ONE SYDNEY HARBOUR

BARANGAROO

R4B SECTION 4.55 MODIFICATION APPLICATION (SSD 6965 MOD 6 AND SSD 8892218 MOD 4)
July 2022

Approved apartment UB-04 floorplan

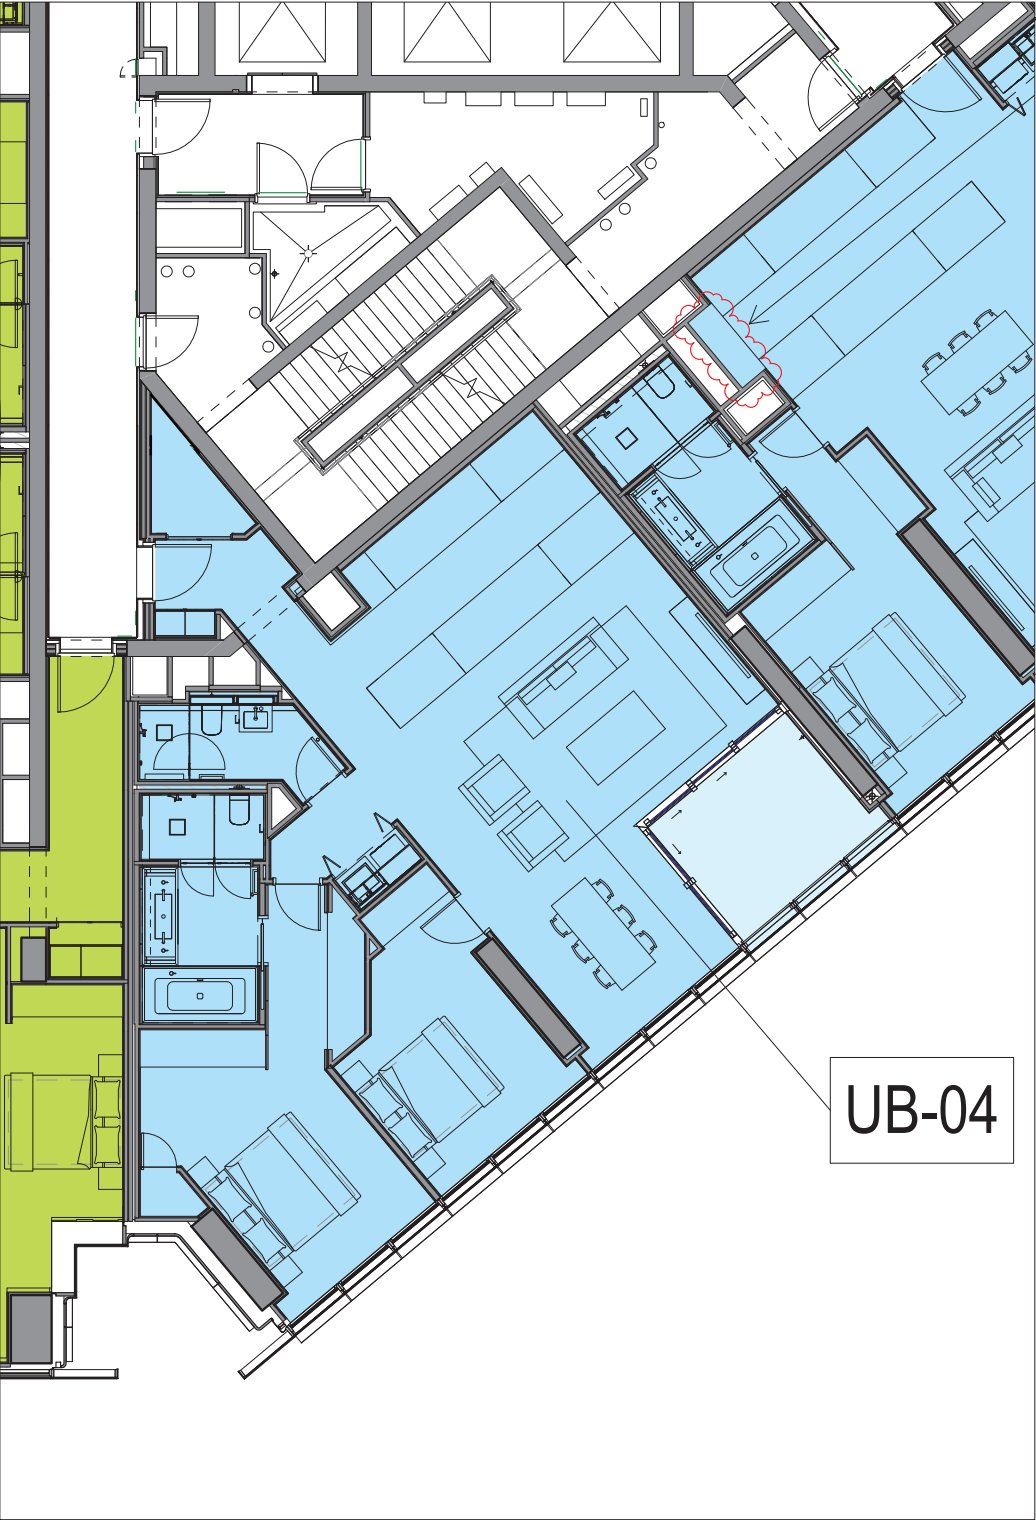
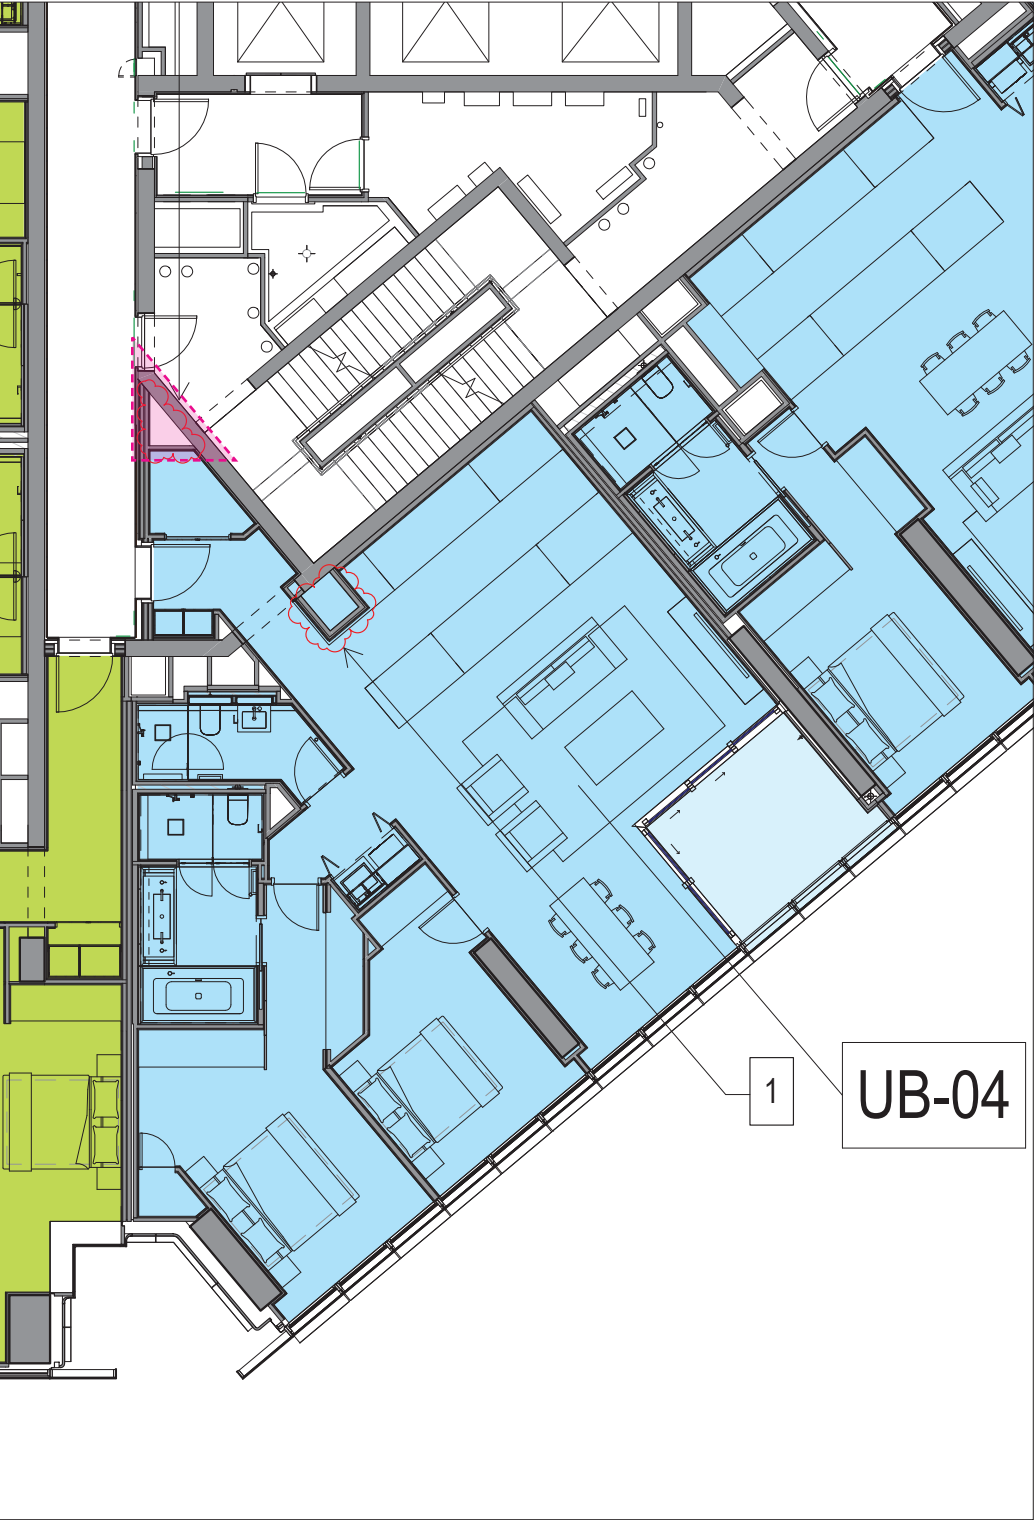
Minor wall adjustments in Apartment UB-04 storage room are proposed as part of a design refinement of this apartment. Squaring off the acute point of the room allows for more functional and accessible storage space. Even with this change, the apartment continues to exceed volume of storage required by the ADG. Redistribution of GFA to a former riser within apartment results in no per unit or overall development GFA changes.

Approved apartment UB-04 floorplan

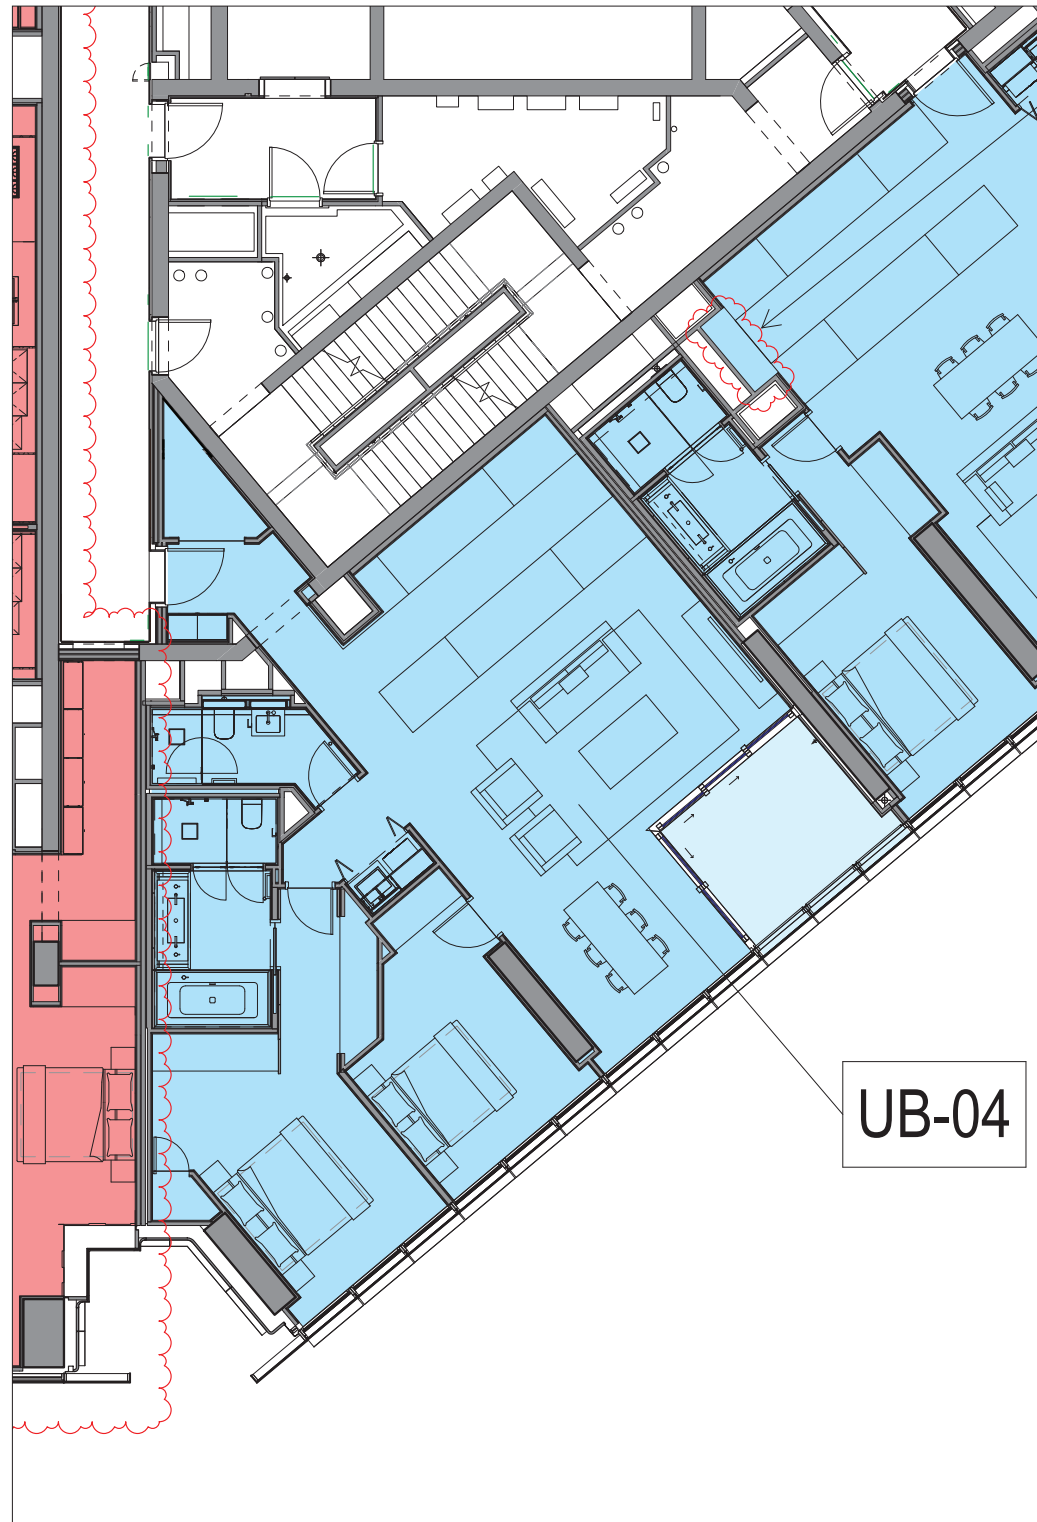
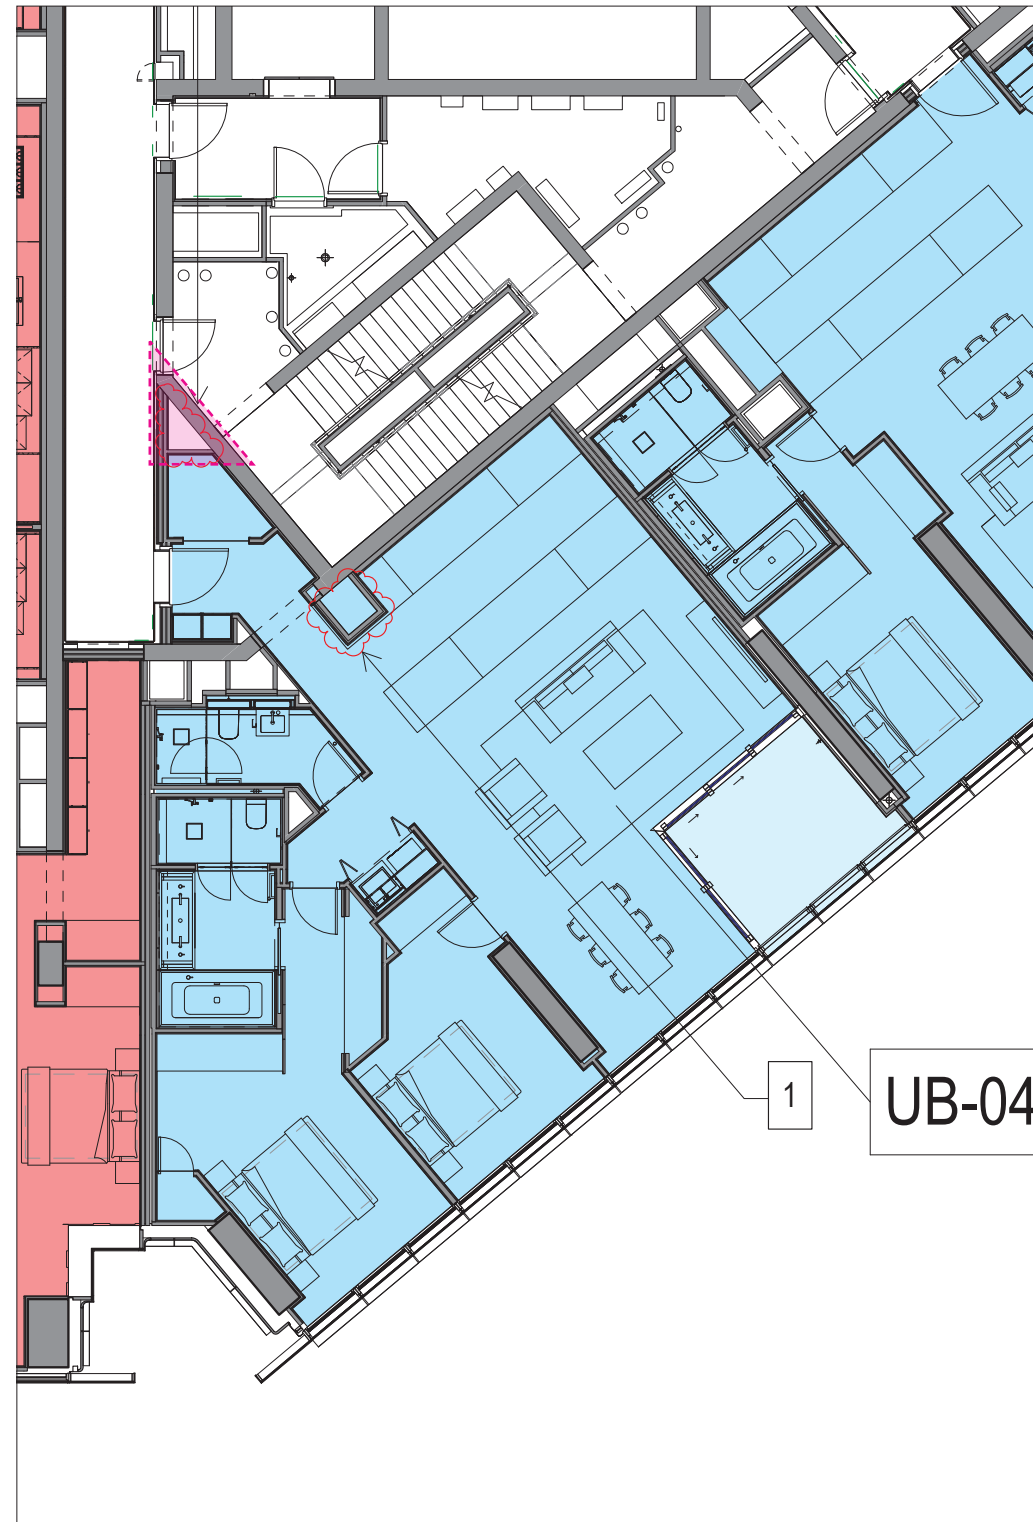
Minor wall adjustments in Apartment UB-04 storage room are proposed as part of a design refinement of this apartment. Squaring off the acute point of the room allows for more functional and accessible storage space. Even with this change, the apartment continues to exceed volume of storage required by the ADG. Redistribution of GFA to a former riser within apartment results in no per unit or overall development GFA changes.

Approved Level 1 Plant Room Layout

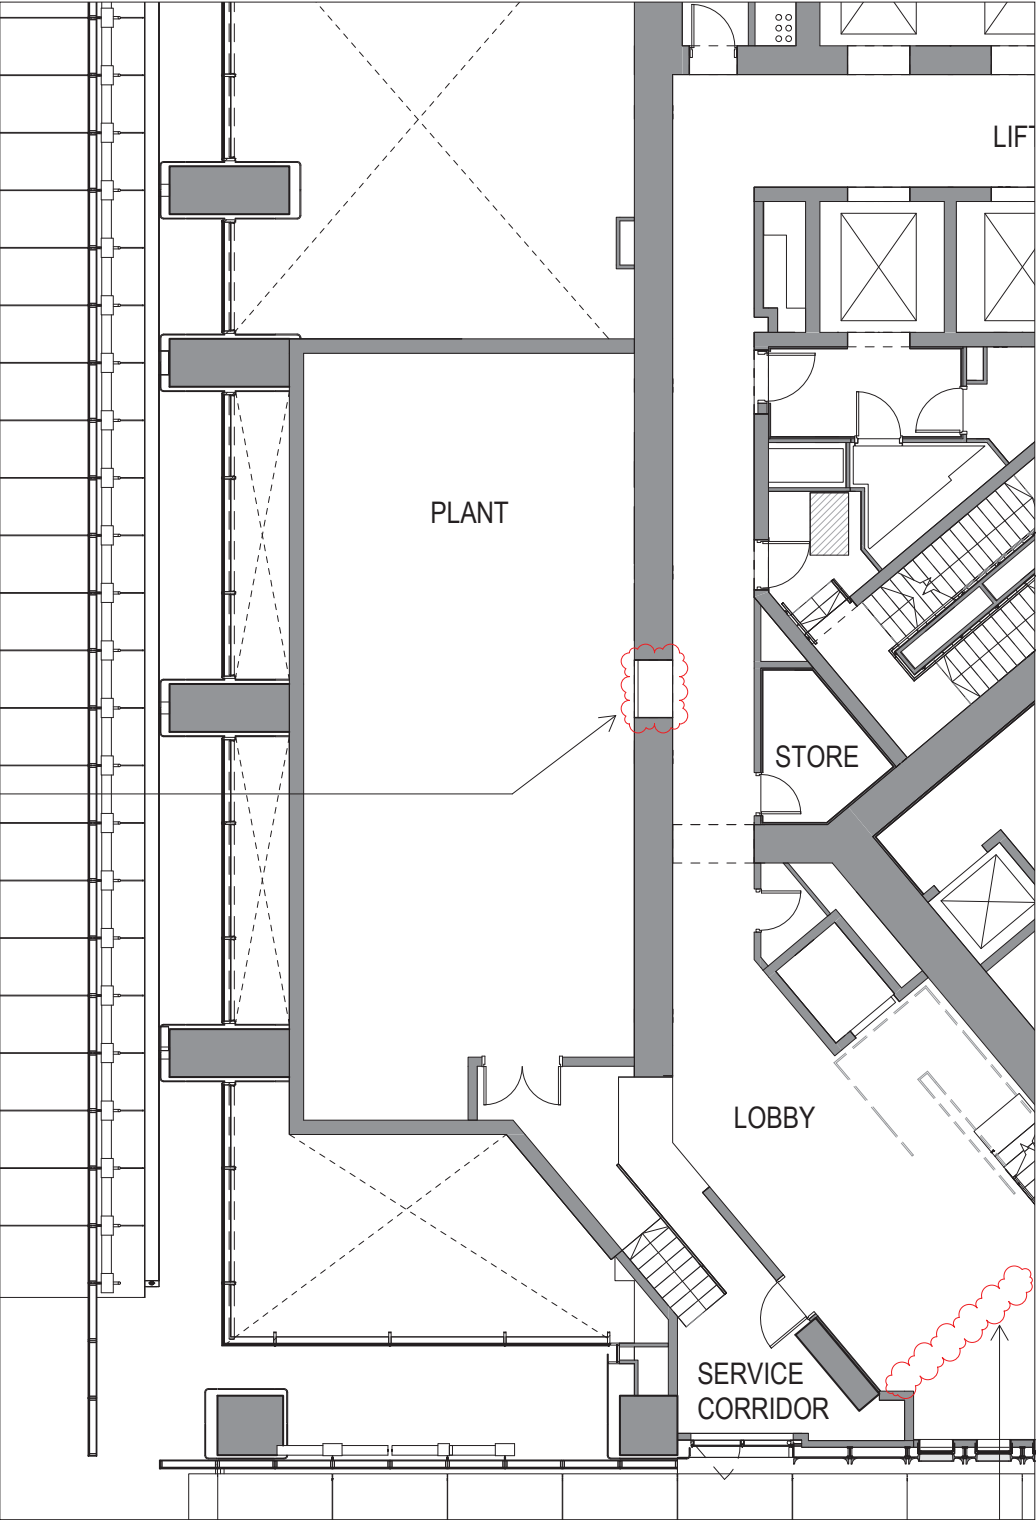
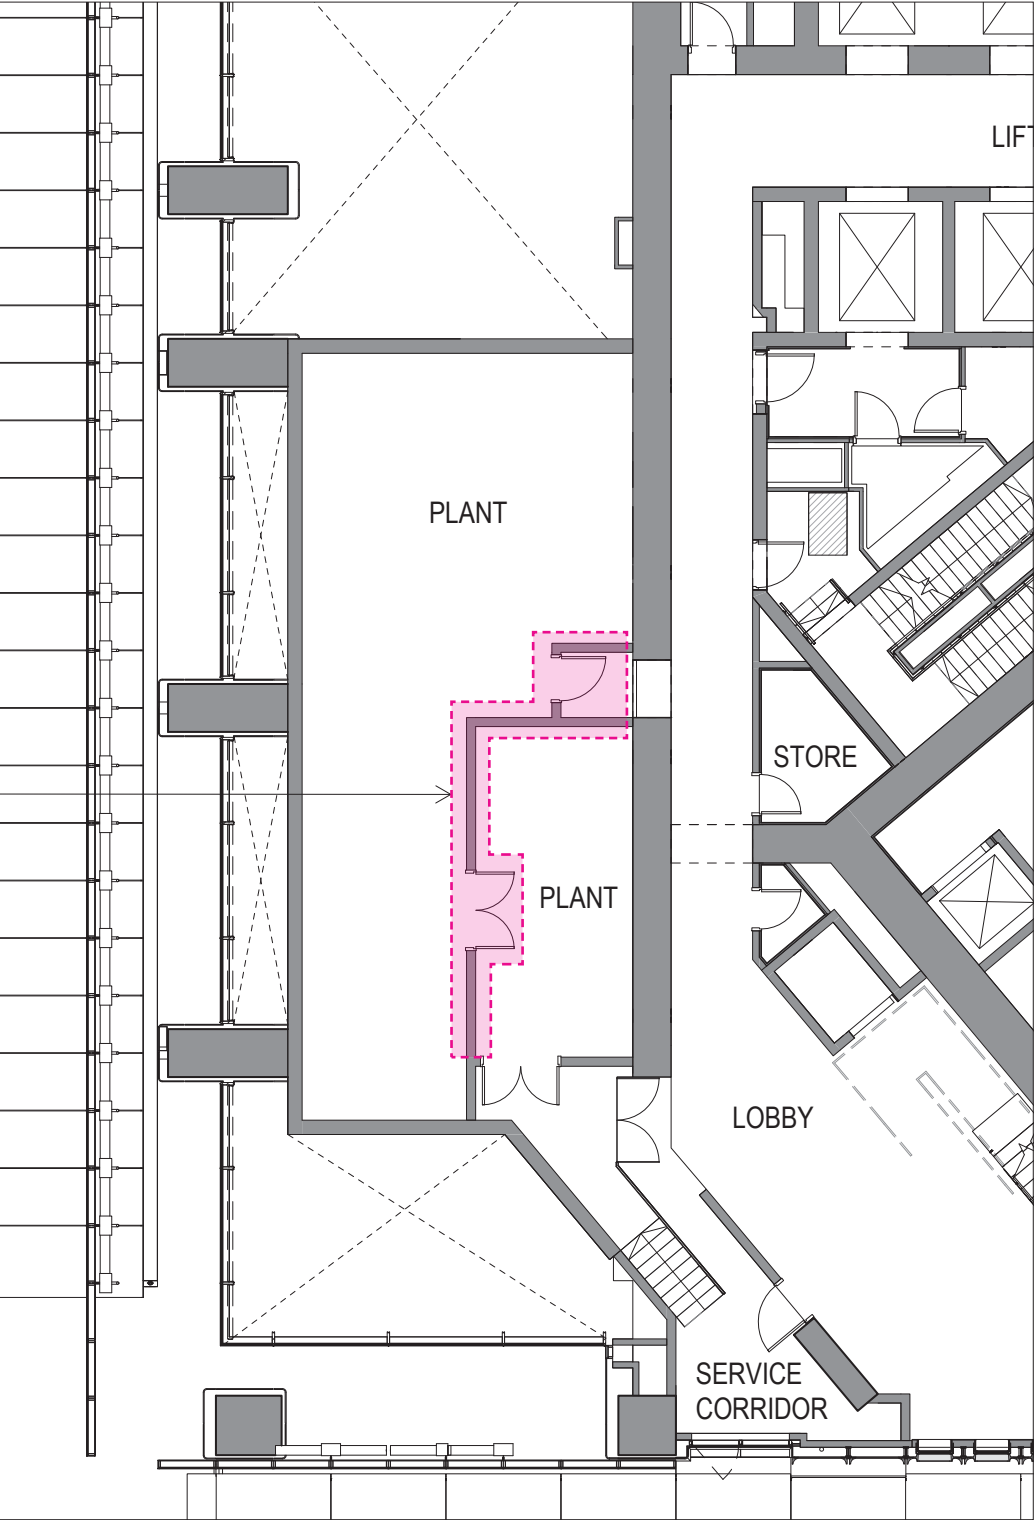
Additional walls and doors added to split existing level 1 plant room into two. These rooms have different functions and are required to be separated from each other. As this is a plantroom area away from the common and residential areas of the building, there is no detrimental impact on amenity.
